Access Compliance Report

Public Rights-of-Way

Intersection ID: 10017066	Main Street: NEAL_RD	Cross Street: N/A	Location: S
ADA ID: C7480E06E5BC	Ramp Type: PerpDiag	Initial Pass/Fail: Fail	Overall Compliance: No
		Severity Score: 25

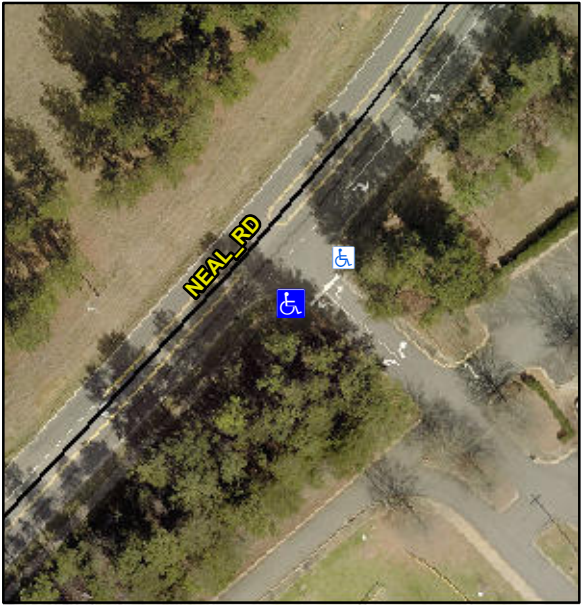
Codes/Mitigation Info/Possible Solution			Field Measurements/Component Compliance		
	Possible Solutions:		Compliance	Description	Data
	Remove & Replace Curb Ramp With Two New Directional Ramps or Equivalent.		No	Ramp Length (in)	10.8
			Yes	Ramp Width (in)	6.2
			N/A	Flare Type LT	N/A
			N/A	Flare Slope LT (%)	N/A
			N/A	Flare Traversable LT?	N/A
			N/A	Landing Length (in)	N/A
			N/A	Landing Width (in)	N/A
			N/A	Landing Slope (%)	N/A
			N/A	Landing X Slope (%)	N/A
			N/A	Landing Curb? (Y/N)	N/A
			N/A	Shared Landing?	N/A
			N/A	Gutter Ponding?	N/A
			N/A	Gutter Lip Ht (in)	N/A
			No	Painted X Walk1?	No
				X Walk 1 Direction	To NE
			N/A	X Walk 1 Width (in)	N/A
				X Walk 1 Slope (%)	6.7
				X Walk 1 X Slope (%)	0.5
			N/A	Ramp inside XWalk1?	N/A
<p>Surveyor Notes:</p> <p>N/A</p> <p>PROW/ADA:</p> <p>R304.2.2, R304.5.3</p>			N/A	Ramp inside XWalk2?	N/A

5.7	Clear Space?	N/A
			6.7	Clear Space to XWalk (in)	N/A
			N/A	Storm Grate/Utility Hazard?	N/A
				Storm Grate/Utility Type	
			N/A		N/A
			Yes	Surface Condition? (G/P)	Good
Street 1 Name	ENTRANCE				
Stop Condition-Street 2	None				
Street 2 Name	NEAL RD				
Stop Condition-Street 1	None				
Total Cost:	\$ 3200.00
